Department of  
Environmental Quality

Subject: Request for Modified Ground Water Discharge Permit Application

## MEMORANDUM

Subject: July 20, 2016 Inspection

Photo 3

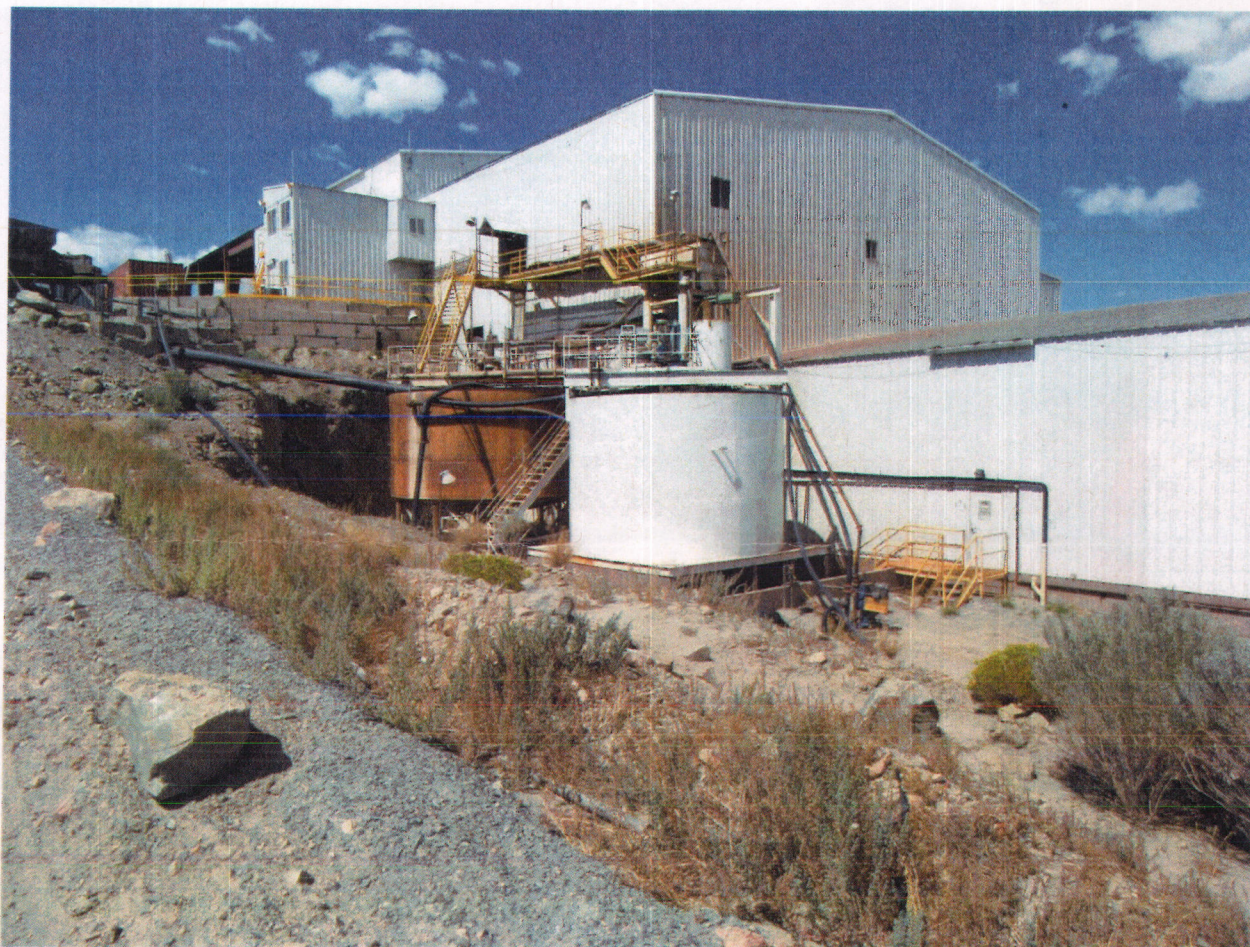
CS Mining is currently taking process water from the ITDF in order to extract copper from solution. The company has also developed a process for neutralizing the water discharged to the ITDF, for eventual use when ore processing resumes. Process water from the ITDF will be pumped into leaching tanks (Photo 3) and mixed with lime kiln dust. From there the mixture will be piped to thickener tanks (Photo 4) where solids settle. The neutralized process water will be used for copper extraction, and neutralized process water with about 50% solids will be pumped from the thickener tank to a booster tank (Photo 5), where it will be mixed with incoming process water from the ITDF and sent back into the neutralization circuit. This process should gradually raise the pH of the process water in the ITDF. CS Mining reports that it may cause a decrease in the dissolved solids content of the process water, as metals and sulfate precipitate from solution.
